# Access Compliance Report

## Public Rights-of-Way

### (Curb Ramps)

Intersection ID: 10019090	Main Street: SHOCCO_LN	Cross Street: N/A	Location: NE
ADA ID: 1CBB022C8E83	Ramp Type: Perp	Initial Pass/Fail: Fail	Overall Compliance: No
Severity Score: 13.75			
Codes/Mitigation Info/Possible Solution		Field Measurements/Component Compliance

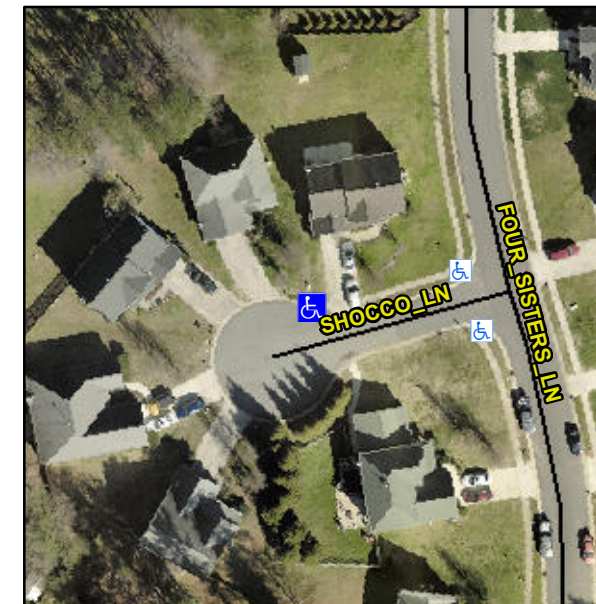
**Not Found, R304.2.2, R304.5.3**

Compliance	Description	Data	Compliance	Description	Data
N/A	Ramp Length (in)	38.5	No	Ramp Slope (%)	10.0
Yes	Ramp Width (in)	52.5	No	Ramp XSlope (%)	3.1
N/A	Flare Type LT	N/A	N/A	Flare Type RT	N/A
N/A	Flare Slope LT (%)	N/A	N/A	Flare Slope RT (%)	N/A
N/A	Flare Traversable LT?	N/A	N/A	Flare Traversable RT?	N/A
N/A	Landing Length (in)	N/A	N/A	DWS Provided?	N/A
N/A	Landing Width (in)	N/A	N/A	DWS Contrast?	N/A
N/A	Landing Slope (%)	N/A	N/A	DWS Length (in)	N/A
N/A	Landing X Slope (%)	N/A	N/A	DWS Full Width?	N/A
N/A	Landing Curb? (Y/N)	N/A	N/A	DWS Offset (in)	N/A
N/A	Shared Landing?	N/A			
N/A	Gutter Ponding?	N/A	N/A	Gutter Slope (%)	N/A
N/A	Gutter Lip Ht (in)	N/A	N/A	Gutter X Slope (%)	N/A
N/A	Painted X Walk1?	No	N/A	Painted X Walk2?	N/A
	X Walk 1 Direction	To SW		X Walk 2 Direction	N/A
N/A	X Walk 1 Width (in)	N/A	N/A	X Walk 2 Width (in)	N/A
	X Walk 1 Slope (%)	6.8		X Walk 2 Slope (%)	N/A
	X Walk 1 X Slope (%)	1.5		X Walk 2 X Slope (%)	N/A

**Remove & Replace Entire Ramp.**
